# MY02 MONITORING REPORT

Dales Creek Restoration Site  
Buncombe County, North Carolina  
French Broad River Basin - 06010105

DMS Project #100128

Date: February 14, 2024  
To: Harry Tsomides, DMS Project Manager  
From: Adam Spiller, Project Manager  
KCI Associates of North Carolina, PA  
Subject: MY-02 Monitoring Report Comments  
Dales Creek DMS #7910, Contract 100128  
French Broad River Basin CU 06010105  
Buncombe County, North Carolina

**Dales Creek Restoration Site  
30-70 Percentile Graph  
WETS Station Name: Asheville, NC**

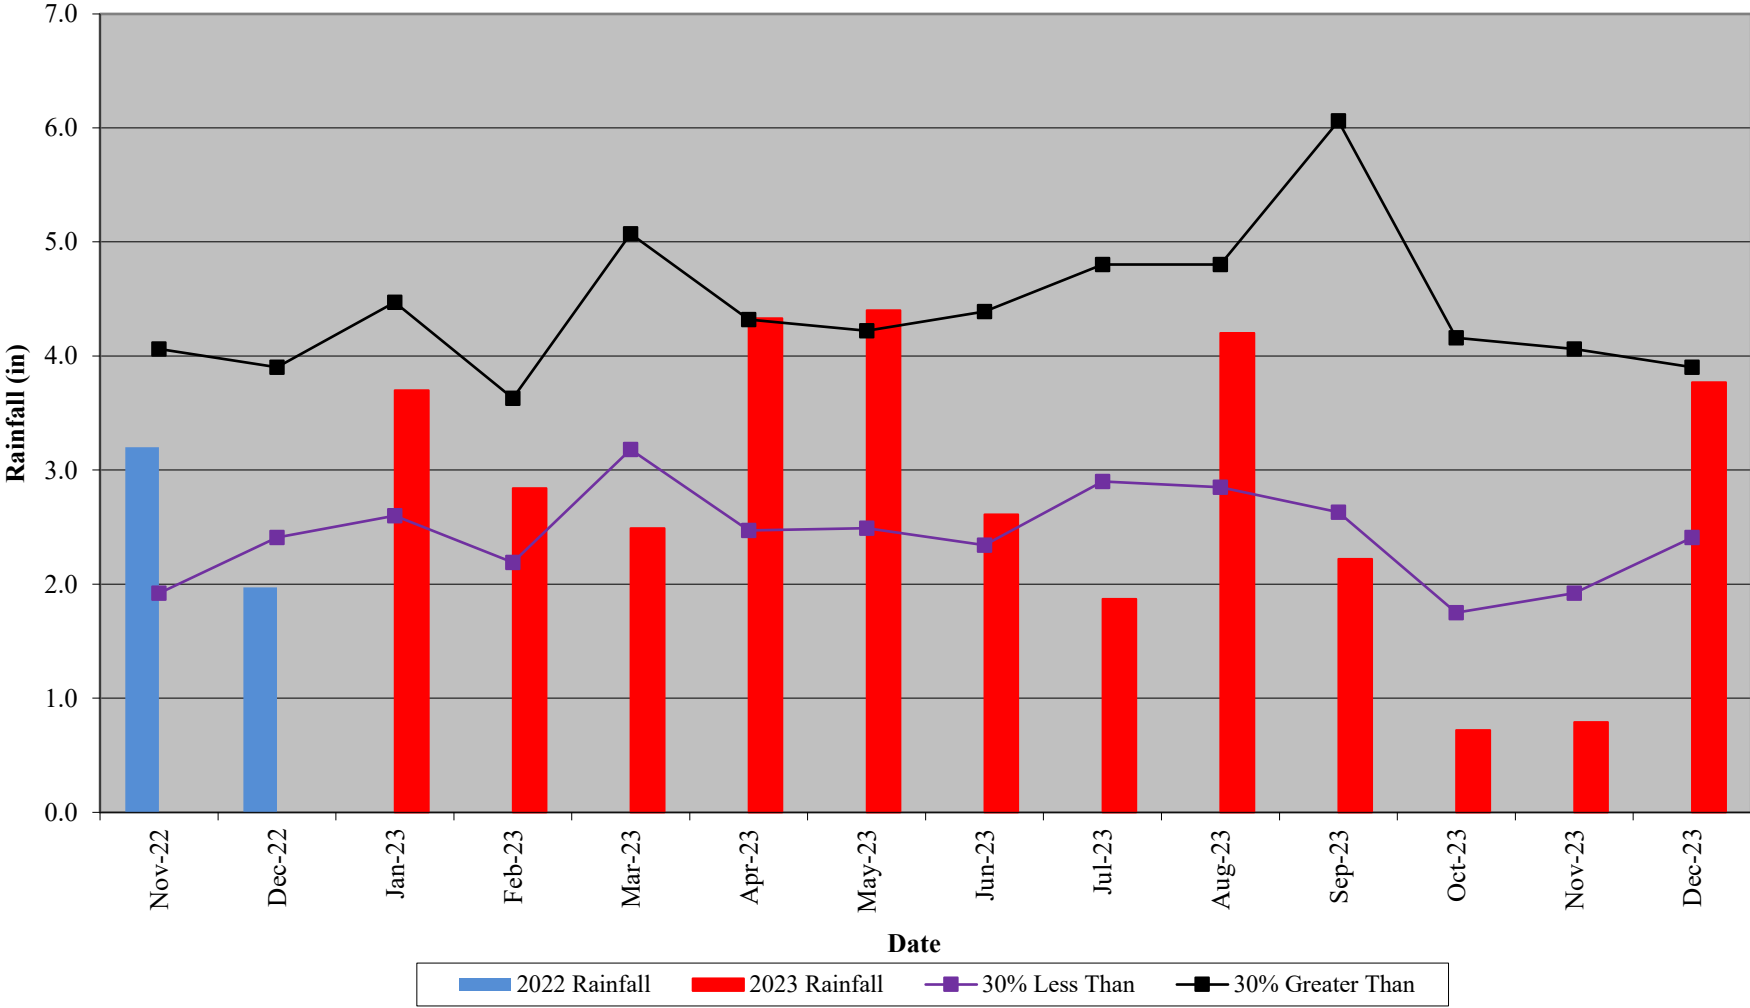
3. During the 2023 Credit Release review meeting the IRT asked KCI to verify the rain data in the MY2(2023) report to confirm that the offsite rain data source is applicable to the project site. Please provide more detail on the rain data source and how it correlates with site rainfall. Also, if possible please provide the 30-70 Percentile Graph for the rain data.  
*KCI Response: The 30-70 has been added to the report as well as a discussion of the rainfall on site in 2023. Rainfall data is obtained from the nearest weather station (Station ID: UNCA) which is located approximately 10 miles east of the site. Comparing the response of the streams on-site to the reported rainfall showed a correlation between large rain events and rises in the stream level/bankfull events. The 2023 data from this station was also compared with the next 4 closest stations to the site. This analysis found that rainfall across the region was generally uniform, with a daily average standard deviation of 0.07 inches and a monthly average standard deviation of 0.5 inches. Based on this analysis and the on-site response to the reported rainfall,*

*KCI is confident that the rain data provided by the UNCA station is correlated with the site rainfall.*
